# UNITED STATES PATENT AND TRADEMARK OFFICE

APPLICATION NO.	FILING DATE	FIRST NAMED INVENTOR	ATTORNEY DOCKET NO.	CONFIRMATION NO.
09/864,389	05/25/2001	Jacob Richter	2390/49704	1194
27123	7590	08/10/2005	EXAMINER	
MORGAN & FINNEGAN, L.L.P. 3 WORLD FINANCIAL CENTER NEW YORK, NY 10281-2101			BUI, VY Q	
			ART UNIT	PAPER NUMBER
			3731

<b>Office Action Summary</b>	<b>Application No.</b> 09/864,389	<b>Applicant(s)</b> RICHTER ET AL.	
	<b>Examiner</b> Vy Q. Bui	<b>Art Unit</b> 3731

DETAILED ACTION

*Fig. 30*

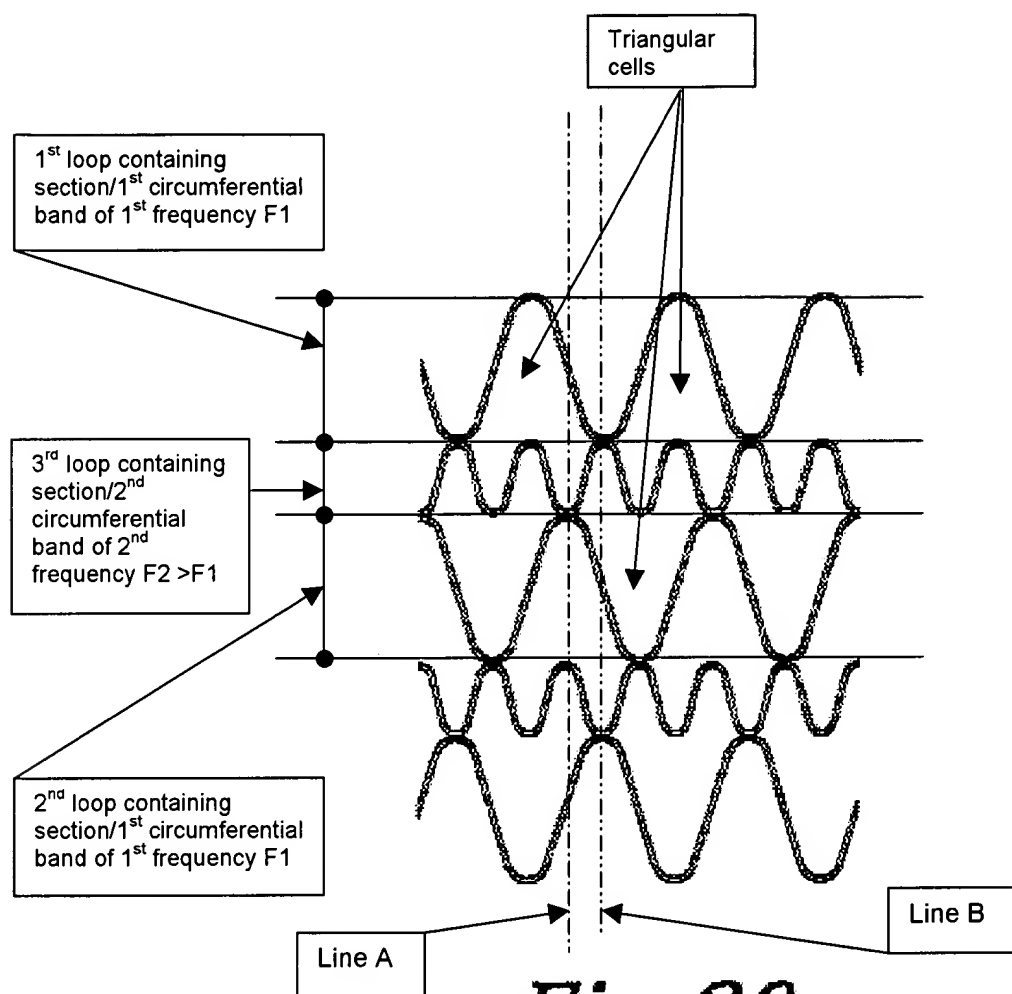
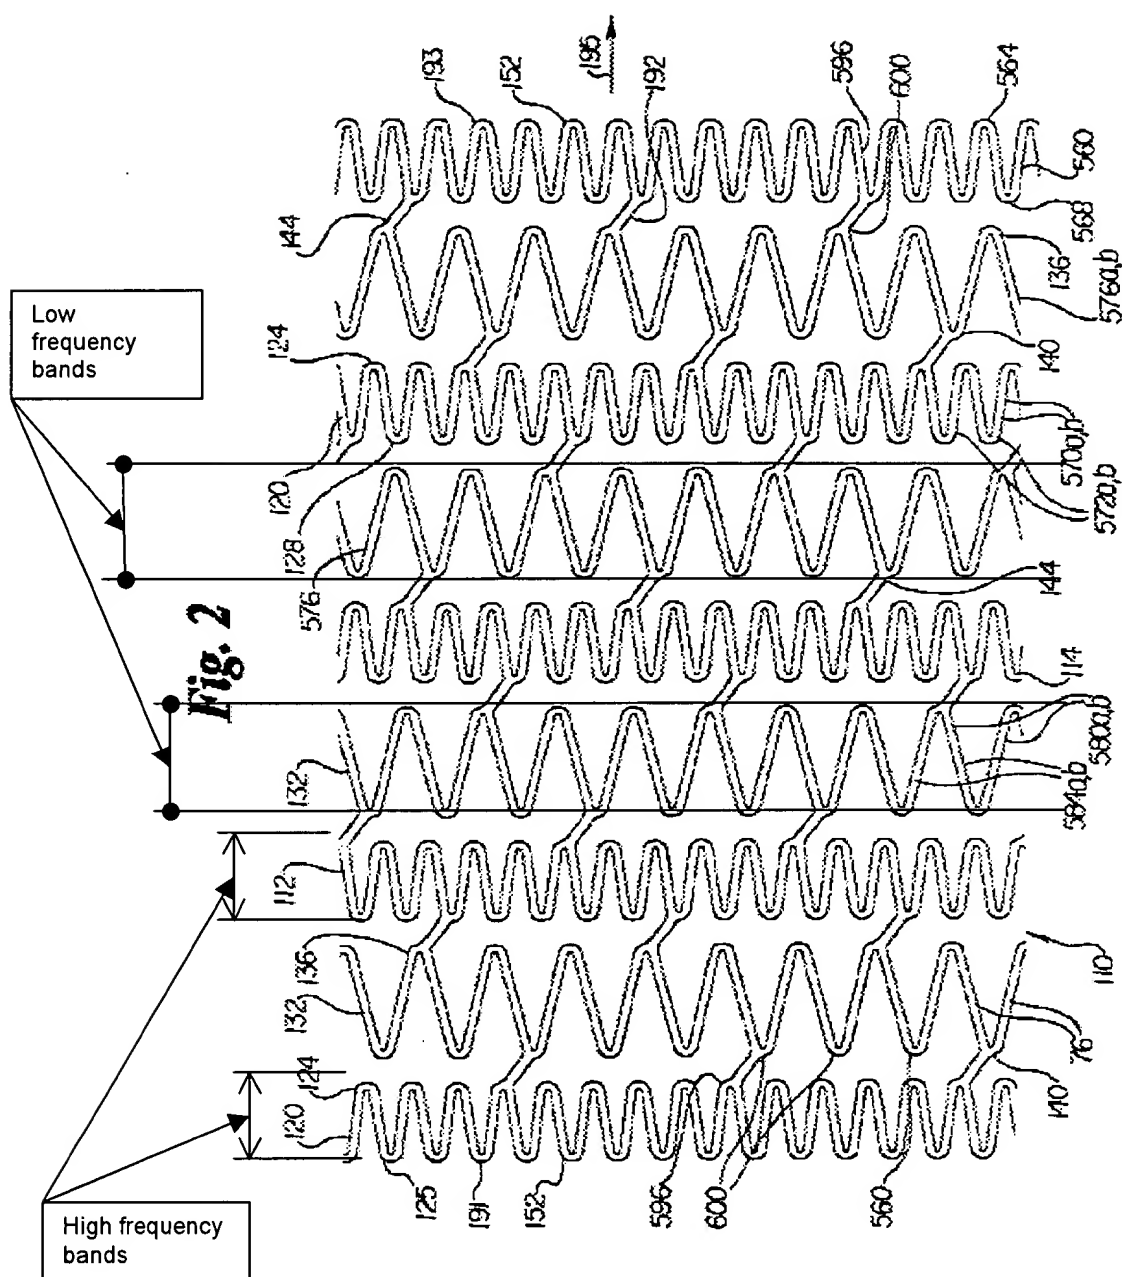
As to claims 1, 6, 11, 42-47 and 49, JAYARAMAN (see Fig. 30 on page 3 above) shows a stent structure comprising 1<sup>st</sup> and 2<sup>nd</sup> loop containing sections/1<sup>st</sup> circumferential bands of a frequency F1, 3<sup>rd</sup> loop containing sections/2<sup>nd</sup> circumferential bands of 2<sup>nd</sup> frequency F2 > F1 to define cells/triangular cells as recited in the claims:

a. 3<sup>rd</sup> loop containing sections are configured in a sinusoidal shape of a frequency F2 higher than a frequency F1 of 1<sup>st</sup> and 2<sup>nd</sup> loop containing sections (Fig. 30, page 3 above), therefore 3<sup>rd</sup> loop containing sections do expand or contract when the stent structure is bent/expanded, thus 3<sup>rd</sup> loop containing sections do contribute to the cells elongating or shortening when the stent is in a curved configuration/expanded configuration.

b. Cells/triangular cells in one side of a neutral axis of bending of the JAYARAMAN stent will be in a tension condition and in the other side of the neutral axis will be in a compression condition. Cells under the tension condition will open in length and narrow circumferentially and cells under the compression condition will shorten in length but widen circumferentially.

c. In an collapsed configuration for deployment/before expansion, lines A and B are substantially closed one to another to make two low frequency adjacent bands out of phase 180° as recited in the claims.

Notice that Jayaraman (6,162,245) and Brown (WO 00/30563) stents have low frequency bands out of phase 180° when the stents are squeezed to a collapsed configuration for deployment in a blood vessel. Further, fig. 8 of Von Oepen (6,193,747) shows low frequency bands are 180° out of phase one to another.

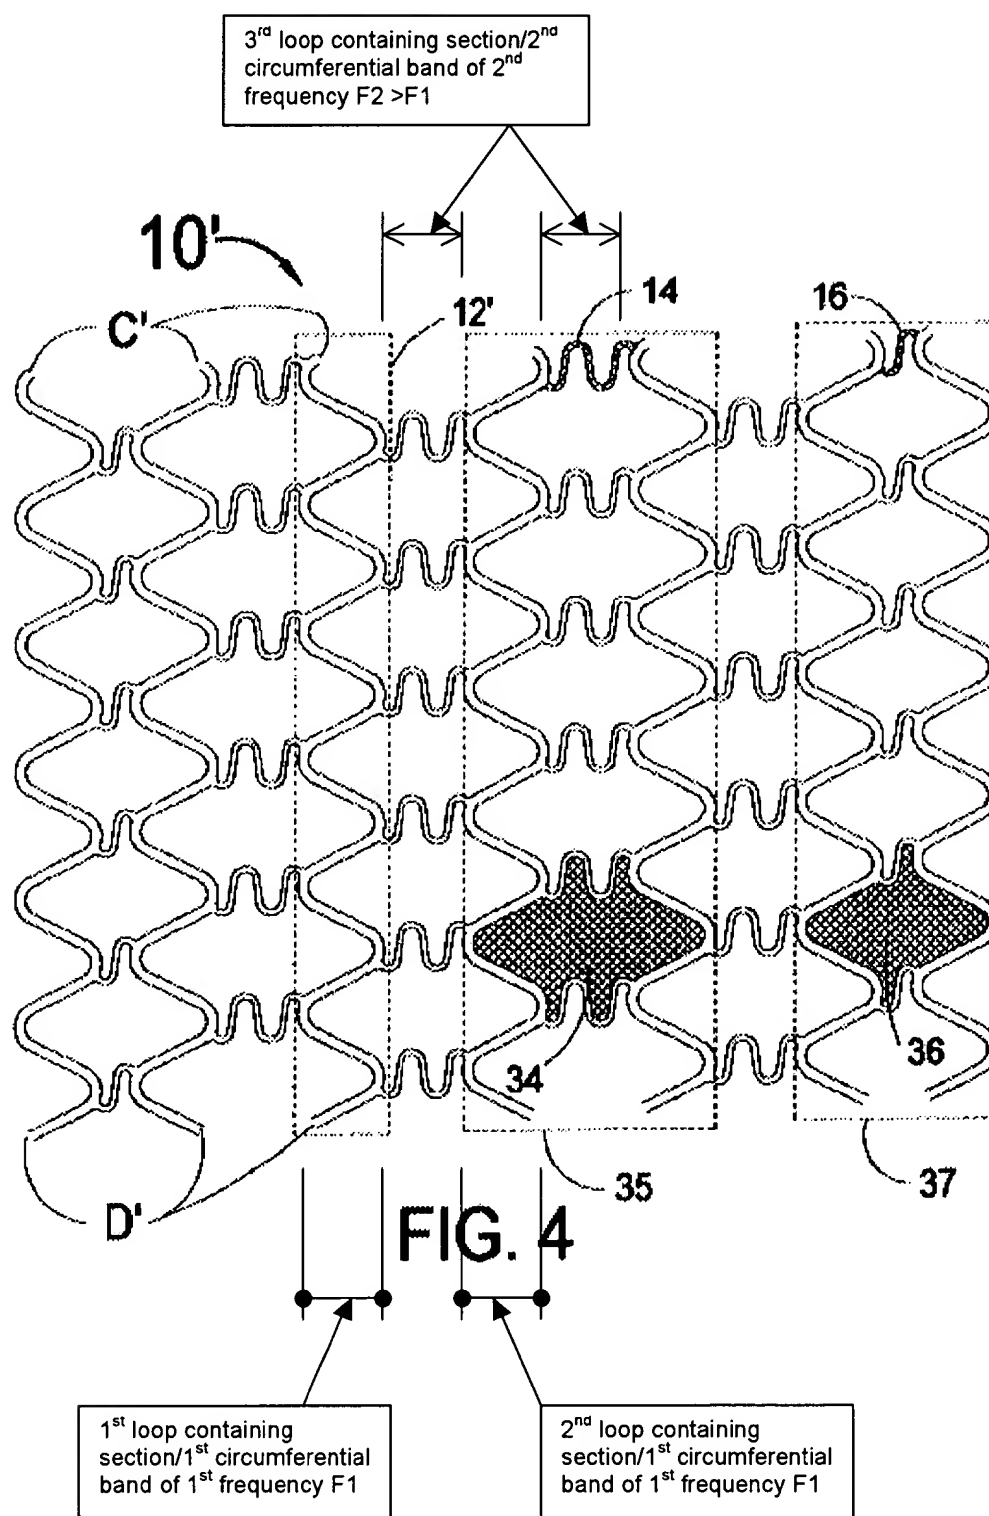
Please refer to Fischell's Fig. 4 reproduced and shown in page 4 of this "Office Action". Fischell-'403 (Fig. 4) disclose substantially all structural limitations of the claimed invention. Notice that there is no limitation in the claims to specify what is the scope of the claims by the term "oriented". Because 1<sup>st</sup> loop containing sections/1<sup>st</sup> circumferential bands of frequency F1, 2<sup>nd</sup> loop containing sections/1<sup>st</sup> circumferential bands of frequency F1, and 3<sup>rd</sup> loop containing sections/2<sup>nd</sup> circumferential bands of frequency F2>F1 extend in circumferential direction of the stent 10' and have a circumferential dimension, therefore, it would be reasonable to consider the 3<sup>rd</sup> loop containing sections/2<sup>nd</sup> circumferential bands as being oriented in a circumferential direction of the stent 10'. Further, if there is no explicit definition of a specific term, such as the term "oriented" as recited in the claims, one cannot transport the specification into the claims.
